Appl. No. 09/762,996
Amtd. Dated June 9, 2005
Reply to Office action of February 14, 2005
Attorney Docket No. PD9778-US1
EUS/J/P/05-1153

REMARKS/ARGUMENTS

Fig. 2

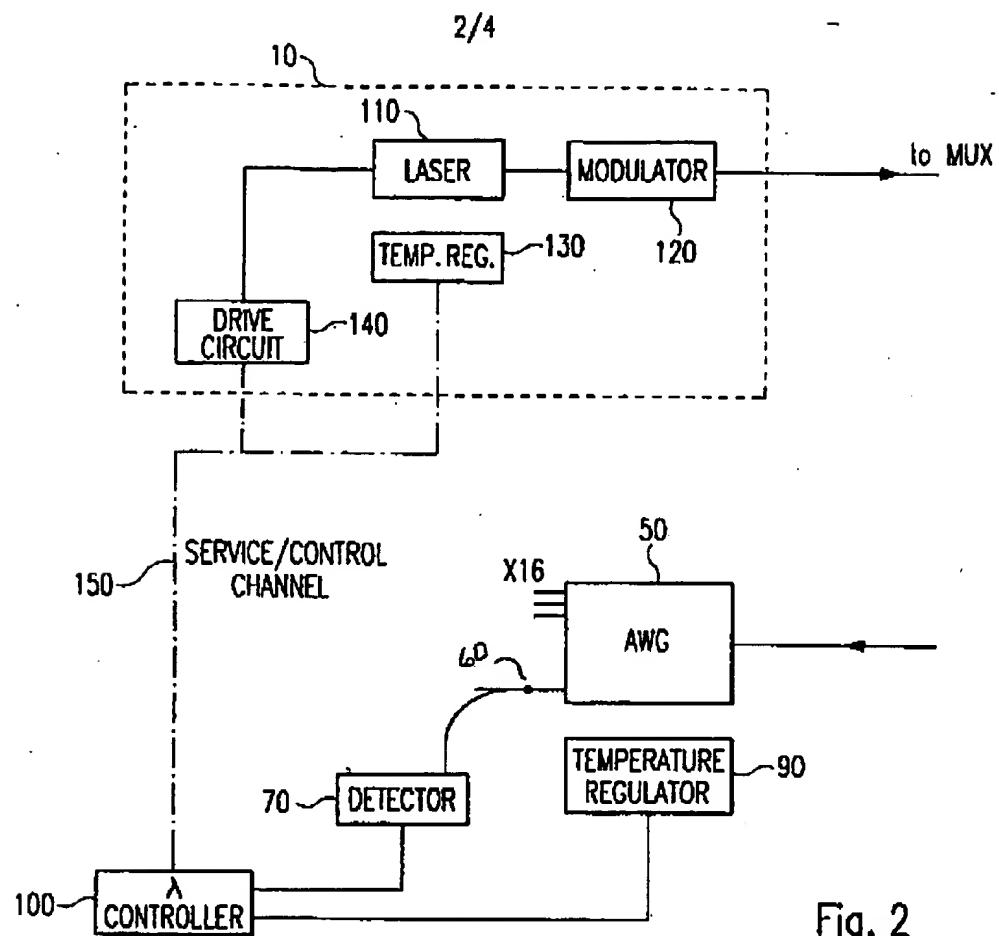
The Examiner objected to Figure 2 as failing to include reference numeral "60." Submitted herewith is a replacement drawing sheet amending Figure 2 to include the missing reference numeral.

The attached drawing sheet includes a change to Figure 2.

Marked to show Changes
